**Comanche Peak Nuclear Power Plant, Units 3 & 4
COL Application**

FSAR Revision 2

Update Tracking Report

Figure 9.4 202 Class 1E Electrical Room HVAC System Flow Diagram

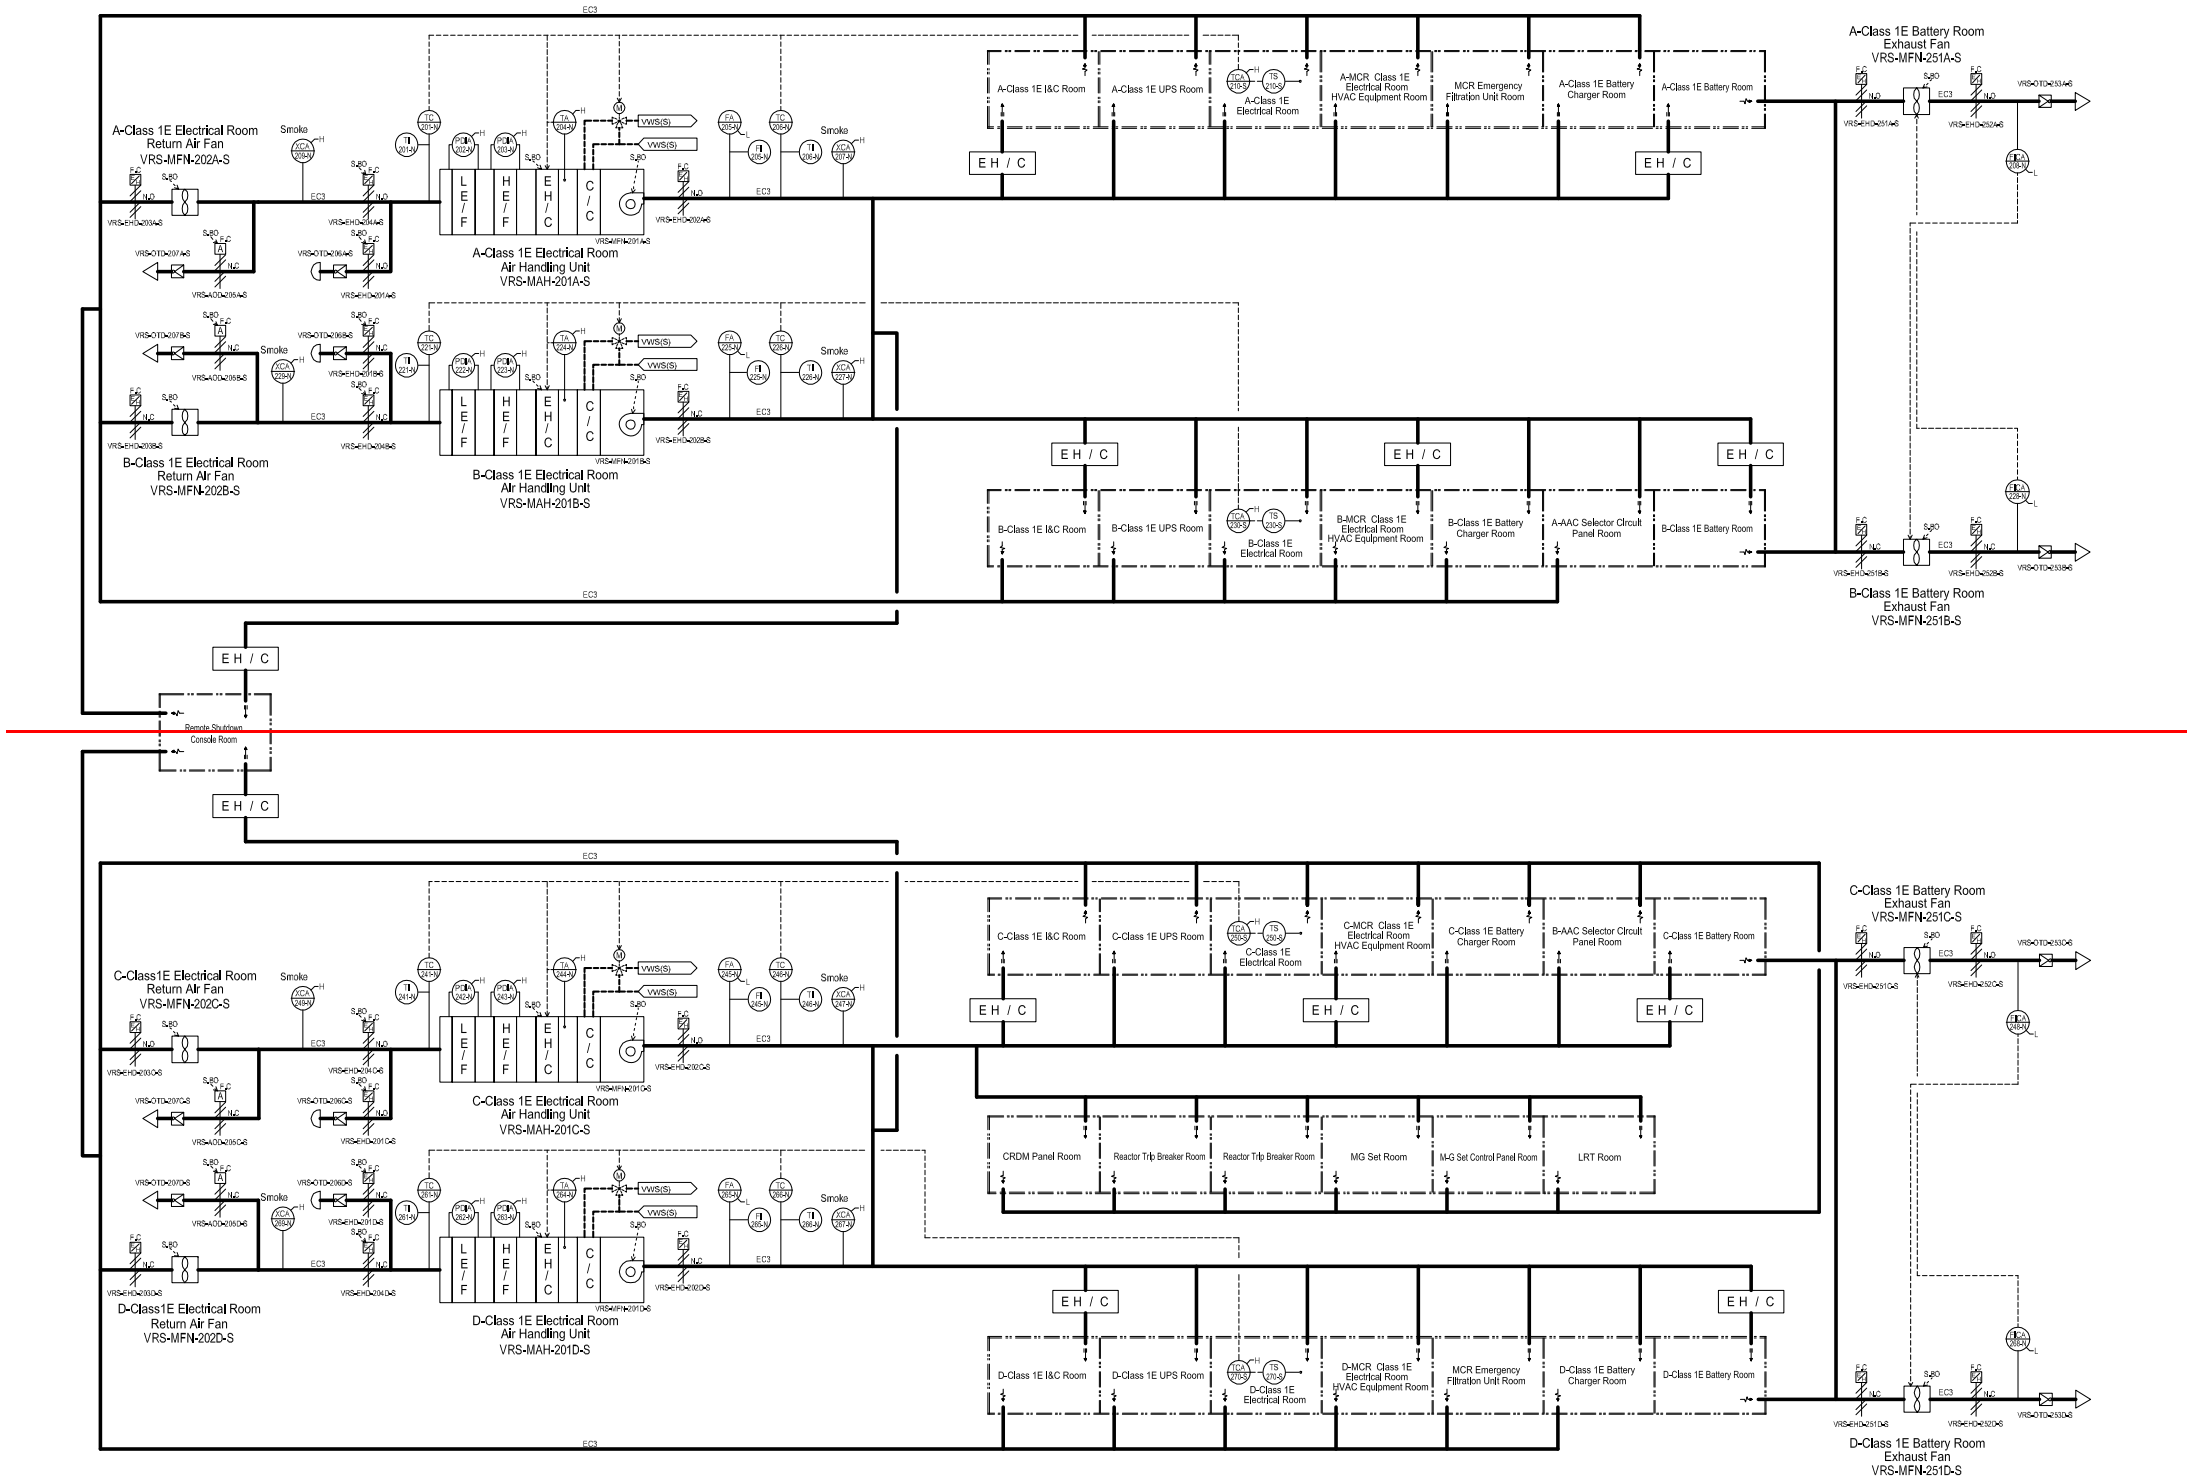
Change ID No.	Section	FSAR Rev. 2 Page	Reason for change	Change Summary	Rev. of FSAR T/R
CTS-01379	9.4.5.2.2	9.4-3	Correction	Removed text reference to Figure 9.4-202 and Table 9.4.5-1.	0
CTS-01380	9.4.5.2.6	9.4-4	Correction	Renumbered Figure 9.4-203 to Figure 9.4-201	0
DCD_09.02.02-72	9.4.7	9.4-8	DCD 09.02.02-72	Clarified COL Applicant requirement for 9.4(4) for heating and cooling coils in air handling units	0
CTS-01378	9.4.7	9.4-8	Correction	Removed Figure 9.4-201 from 9.4(4).	0
CTS-01379	9.4.7	9.4-8	Correction	Removed Figure 9.4-202 from 9.4(4).	0
CTS-01380	9.4.7	9.4-8	Correction	Renumbered Figure 9.4-203 to Figure 9.4-201	0
CTS-01378	Table 9.4-201	9.4-9	Clarification	Added Non-Class 1E Electrical Room AHU heating coil capacity as non-heating	0
CTS-01378	Figure 9.4-201	9.4-18	Correction	Removed Figure 9.4-201. DCD figure is now IBR.	0
CTS-01379	Figure 9.4-202	9.4-19	Correction	Removed Figure 9.4-202. DCD figure is now IBR.	0

~~The Class 1E electrical room HVAC system is shown in Figure 9.4-202 and system equipment design data is presented in Table 9.4.5-1.~~ The capacity of heating coils that are affected by site specific conditions is shown in **Table 9.4-201**.
